RESOLUTION NO. R- 2314

A RESOLUTION OF THE CITY COUNCIL OF THE CITY OF KIRKLAND APPROVING THE PRELIMINARY PLAT OF "FINKBEINER ADDITION TO KIRKLAND", AS APPLIED FOR BY STAFFORD HANSELL COMPANY, BEING DEPARTMENT OF COMMUNITY DEVELOPMENT FILE NO. SUB-75-26(H), AND SETTING FORTH CONDITIONS TO WHICH SUCH PRELIMINARY PLAT SHALL BE SUBJECT.

DEPARTMENT OF COMMUNITY DEVELOPMENT
ADVISORY REPORT
 FINDINGS, CONCLUSIONS AND RECOMMENDATIONS

FILE NUMBER SUB-75-26 (H)
 APPLICANT Stafford Hansell Company
 PROPERTY LOCATION Betw NE 60th St & 58th St & BNR 6 & Approx 106th Ave. NE
 Application for Preliminary Subdivision (Finkbeiner Add. to Kirkland) to divide one parcel into 21 lots.
 SUBJECT _____
 HEARING/MEETING DATE _____
 BEFORE _____

EXHIBIT "A"
R-2311

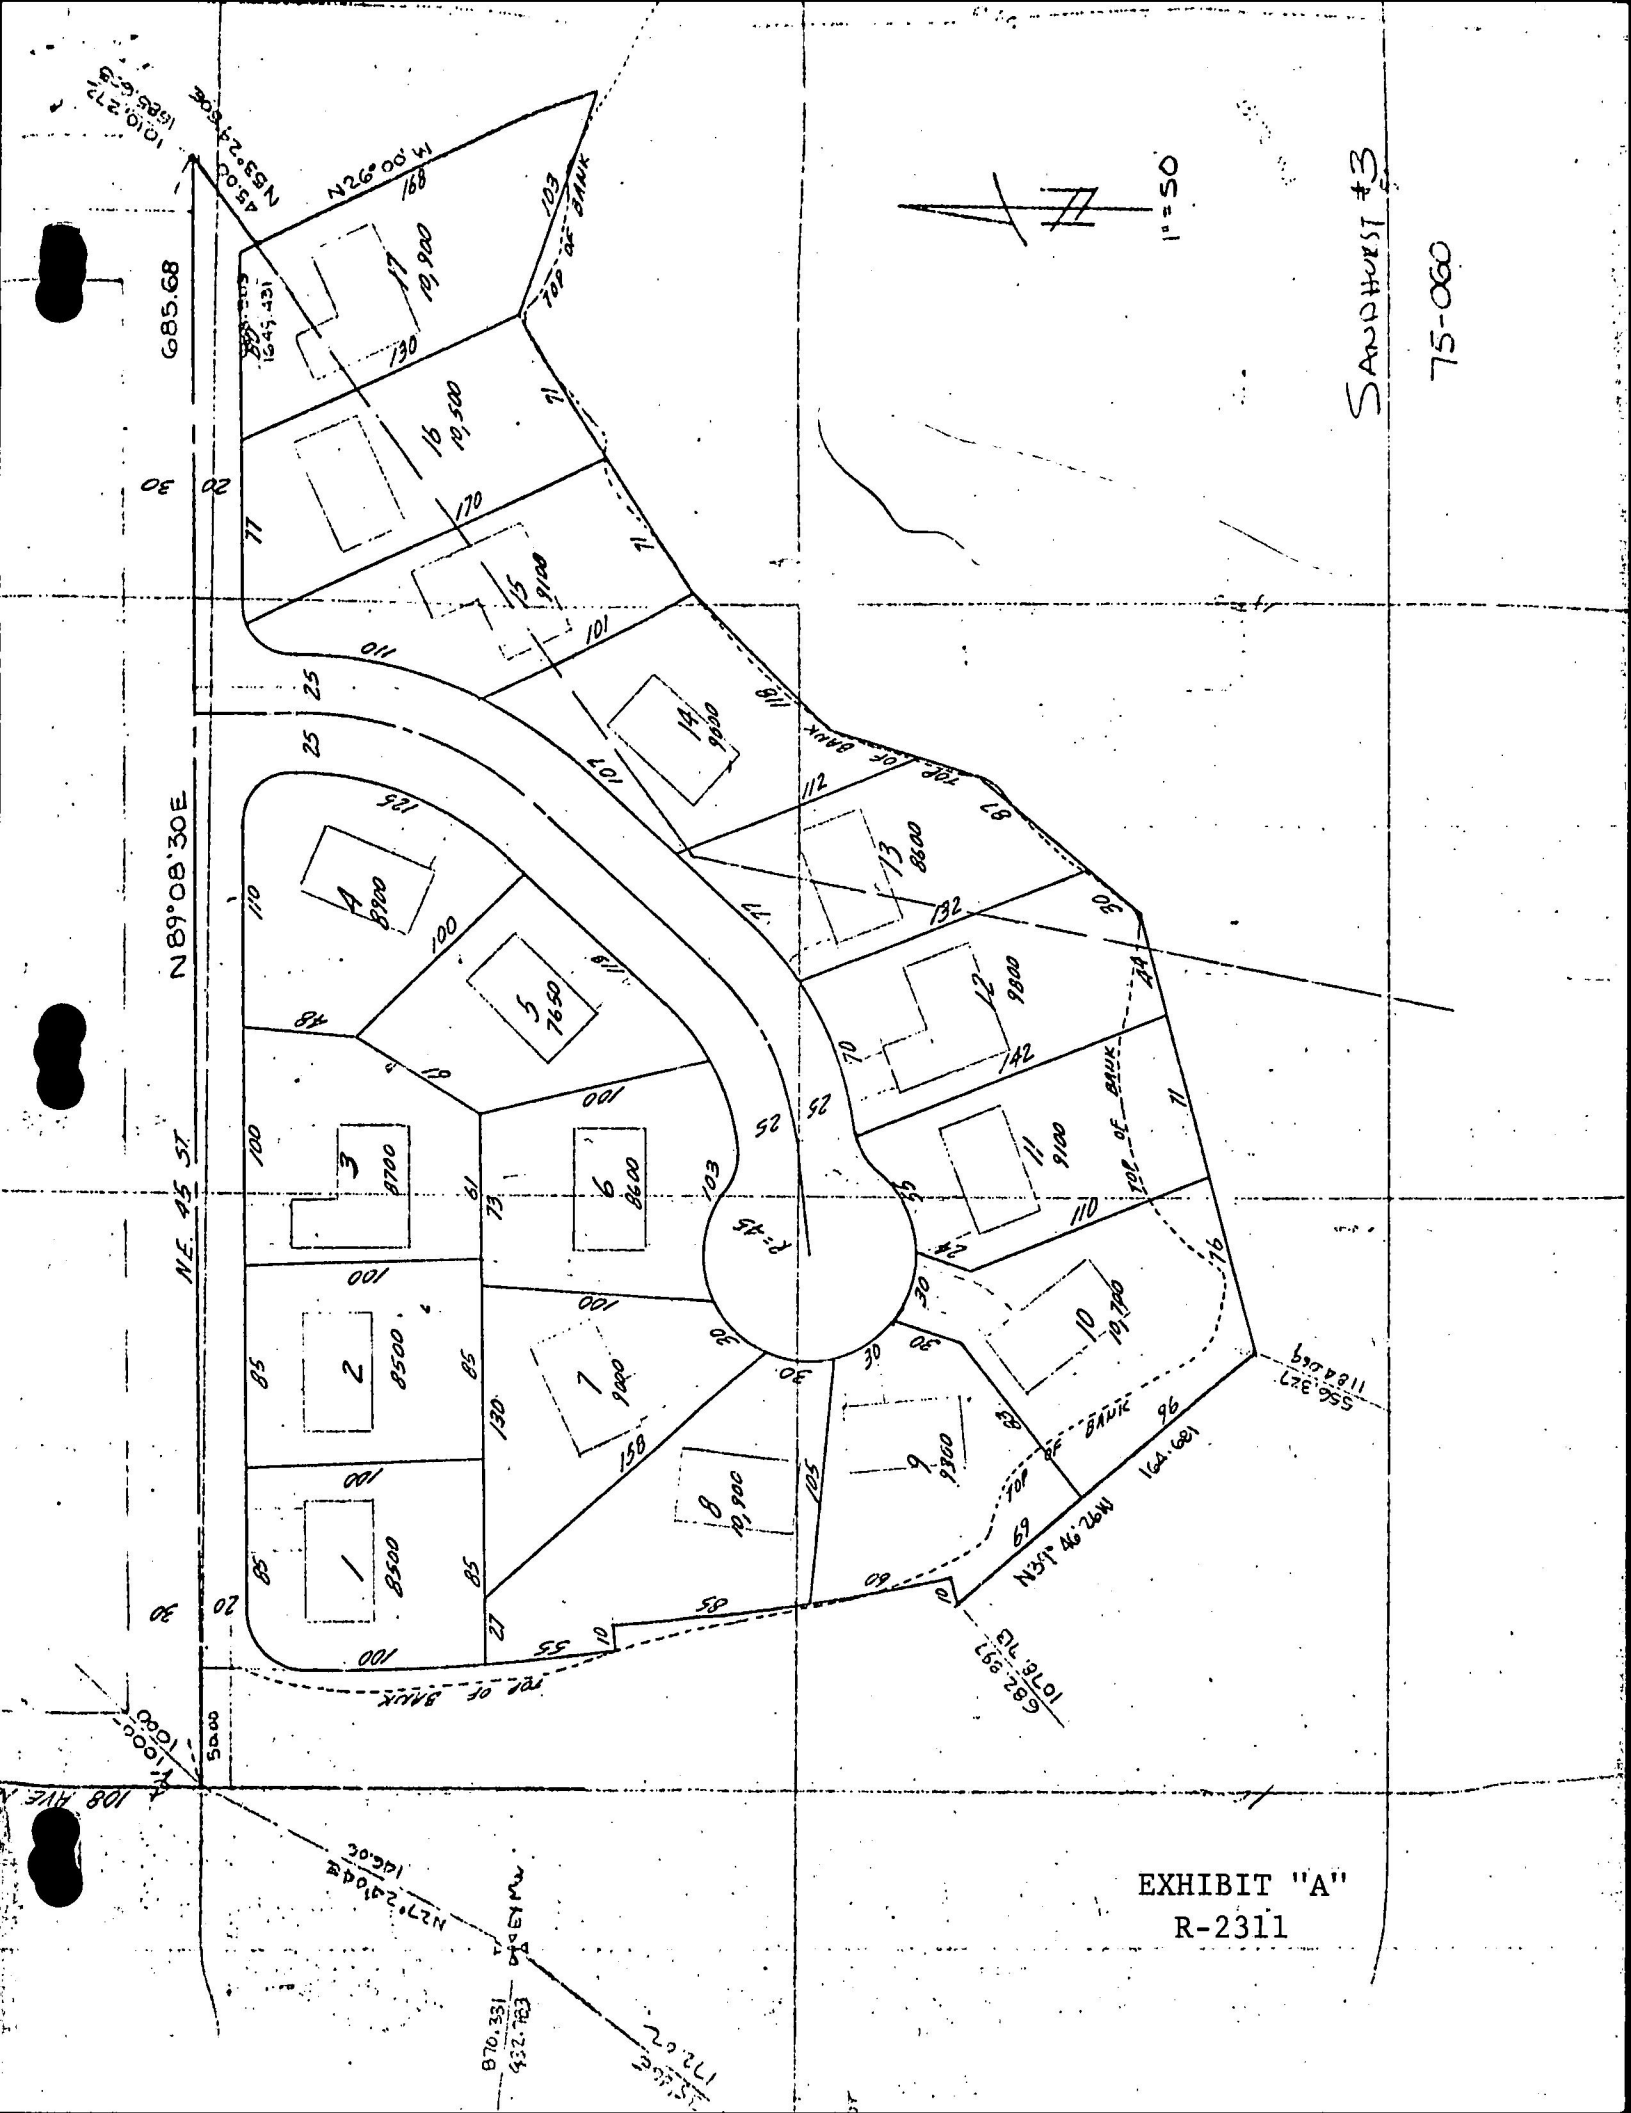
17. The applicant has submitted a tree cutting plan. (See Exhibit "A")
18. The applicant should be required to provide calculations and design drawings which will minimize soil erosion potential.

Based upon the foregoing Findings and Conclusions we hereby recommend approval of this preliminary plat of "Finkbeiner Addition to Kirkland" identified in Exhibit "A" subject to the following conditions:

1. Prior to the installation of any required utilities, grading, clearing, or development within the preliminary plat, however excluding a building permit for Tract "A", the applicant shall submit engineering calculations, drawings, drainage design for the entire plat, and design proposed storm water retention system and erosion measures to be taken during construction and after development so that the velocity and quantity of runoff from the site does not exceed the existing runoff from a 10-year, one-hour storm. This shall include a drainage easement along the undeveloped portion of N.E. 58th Street. Natural drainage controls will be preferred over structural methods within the plat.

2. Removal of vegetation shall be limited to those trees within the right-of-way, utility easements, and homestead clearing with individual trees within the proposed lots to be identified and tagged, and approved by the Department of Community Development prior to tree removal within these lots. Those trees within the landscaping island shall be retained.
